**To: Clean Environment Commission  
MMTP**

**Reducing Adverse Impact of  
Transmission, Line Capacity & Land Use**

**Dennis Woodford P.Eng.,**

**Manitoba Wildlands**

**Figure 7 – Tower design and costing help**

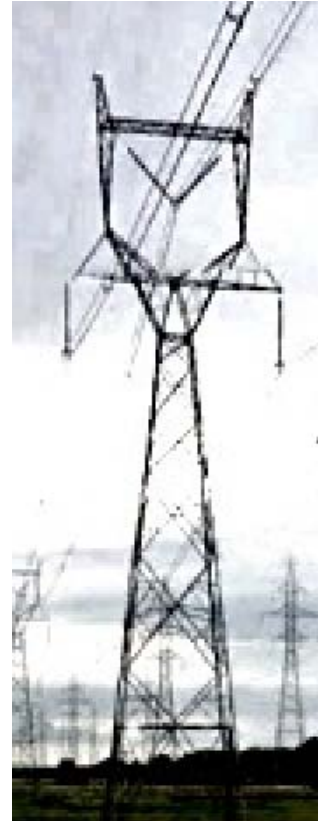
Bystrup of Denmark would welcome working with Manitoba Hydro to compare cost comparisons between the MMTP lattice design and a tubular steel design

**Figure 8 – Benefits to tubular towers**

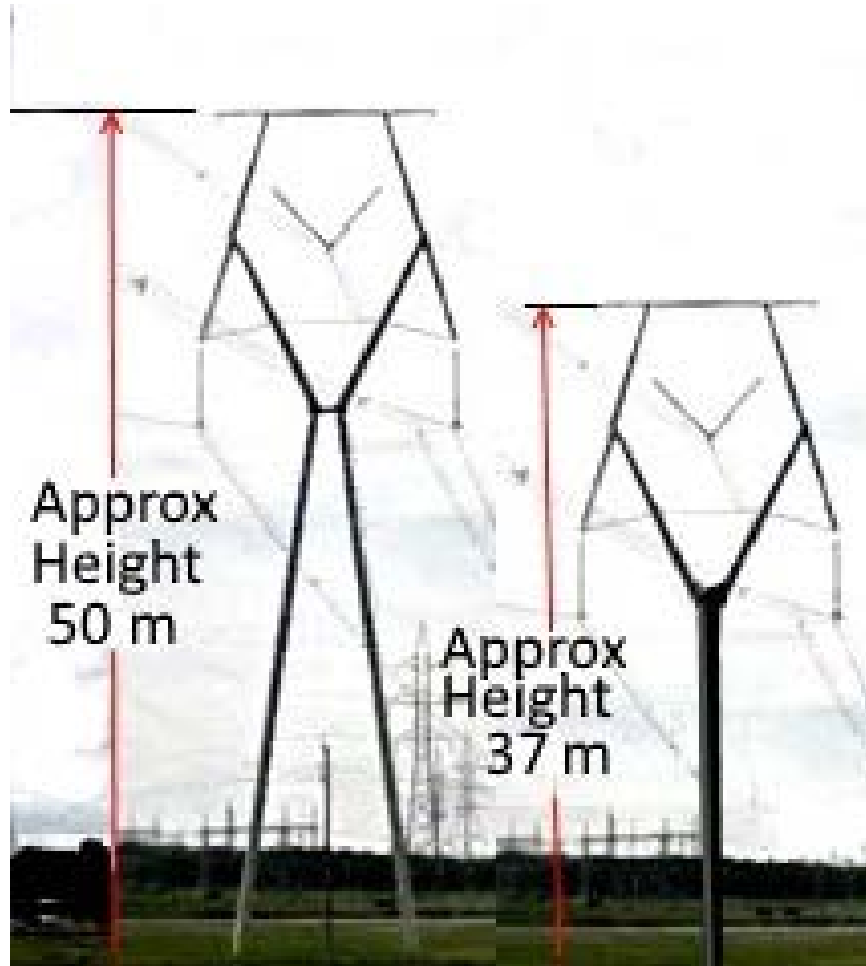
1. Saves environmental footprint and ROW
2. Reduces weed control costs
3. Less maintenance & faster installation
4. **Better landscape and visual effects**

Figure 14 – Other export possibilities

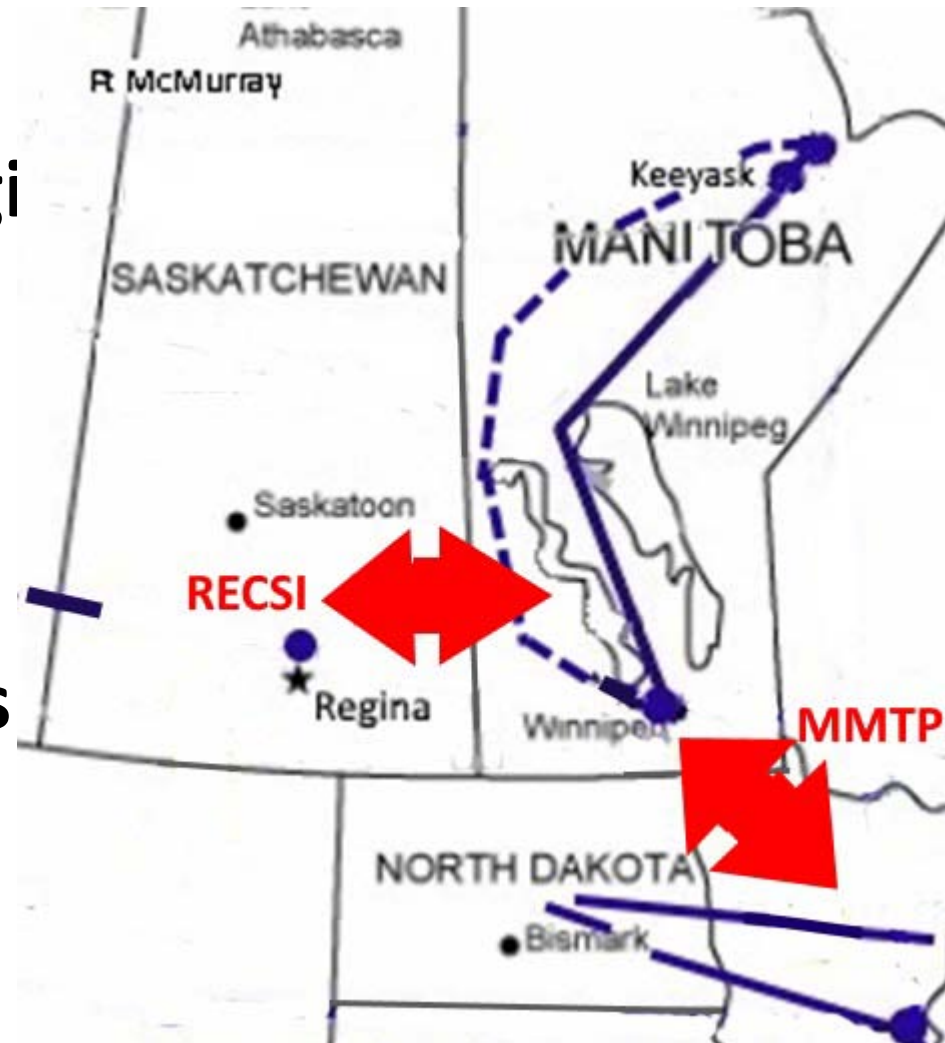
Regional Electricity  
Cooperation and Strategic  
Infrastructure Initiative  
(RECSI) a possibility –  
Should not finalize an  
MMTP agreement until  
the likelihood of RECSI is  
known

**Figure 23 – Shorter span - less swing out**

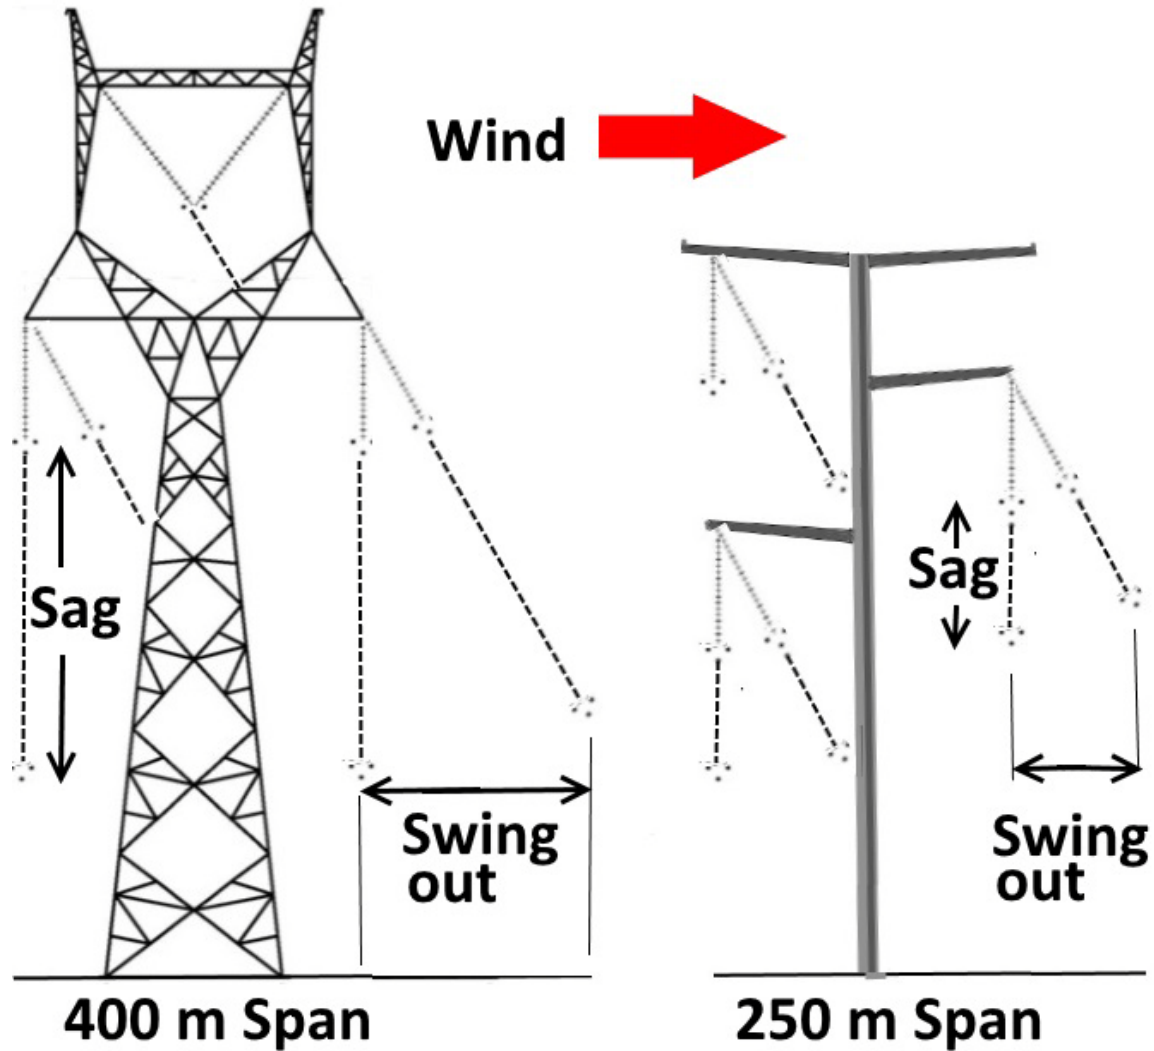
**Swing out adds  
to ROW width**

**400 m span  $\approx$   
32 m swing out**

**250 m span  $\approx$   
15 m swing out**

**ROW 34 m less  
 $(32-15) \times 2 = 34$  m**

**Figure 29 – Access requirements**

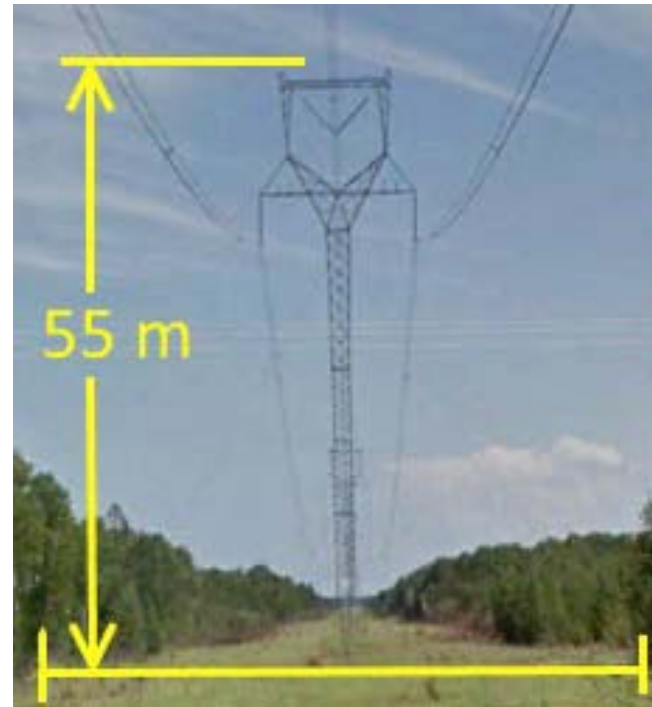
Is access requirement the determining factor needing an 80 m ROW? Consider:

**Figure 34– Comparing transmission towers**

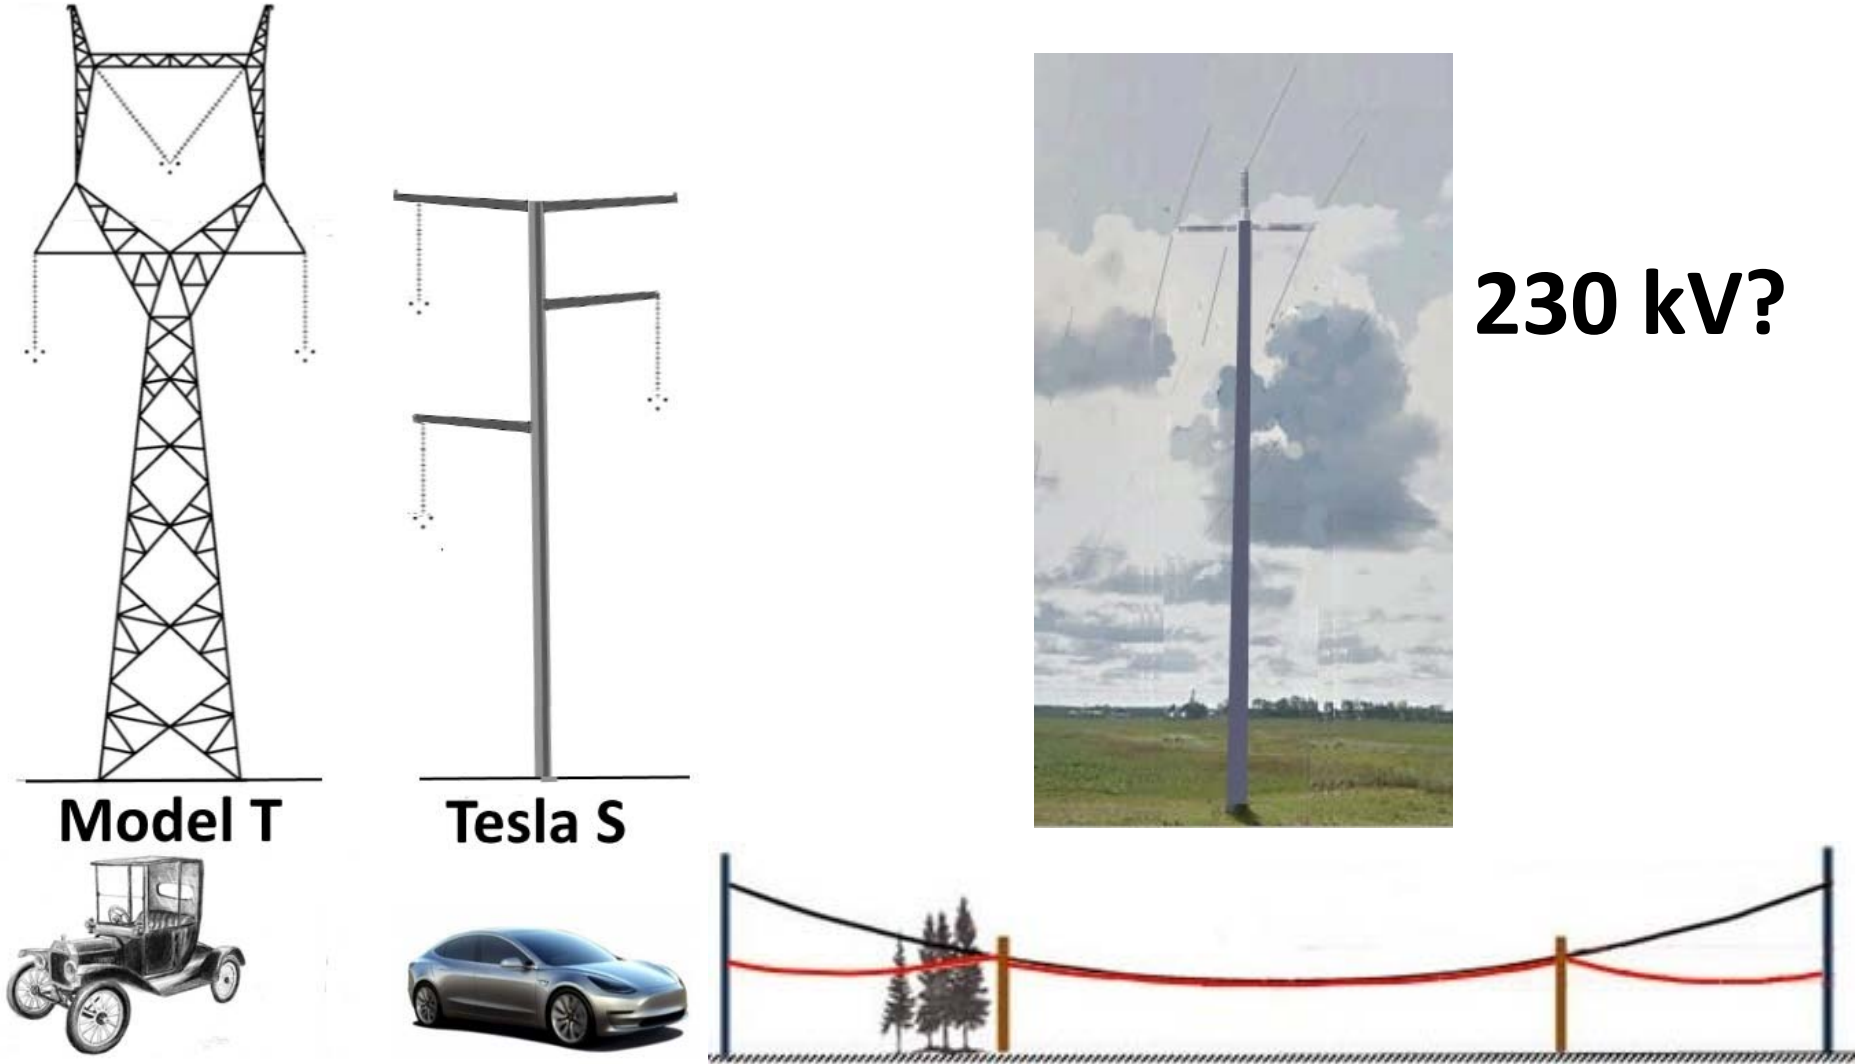
The only transmission line  
presented to the public

Impacted persons not  
consulted on transmission  
line design

Recent trend is to allow  
choice of towers to public
